# Access Compliance Report

## Public Rights-of-Way

| Intersection ID: 13618                  | Main Street: S_CALDWELL_ST | Cross Street: TEMPLETON_AV              | Location: S            |
| ADA ID: 14B4B89D0EAD                    | Ramp Type: PerpDiag        | Initial Pass/Fail: Fail                 | Overall Compliance: No |

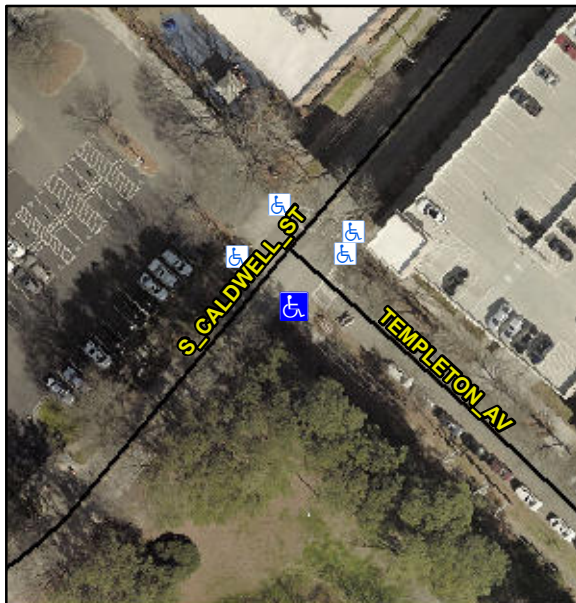
**R304.2.2, R304.5.3**

| Compliance | Description           | Data  | Compliance | Description                 | Data  |
|------------|-----------------------|-------|------------|-----------------------------|-------|
| N/A        | Ramp Length (in)      | 67.0  | No         | Ramp Slope (%)              | 9.1   |
| Yes        | Ramp Width (in)       | 192.0 | No         | Ramp XSlope (%)             | 5.3   |

**Remove & Replace Curb Ramp With Two New Directional Ramps or Equivalent. Restripe Crosswalk.**
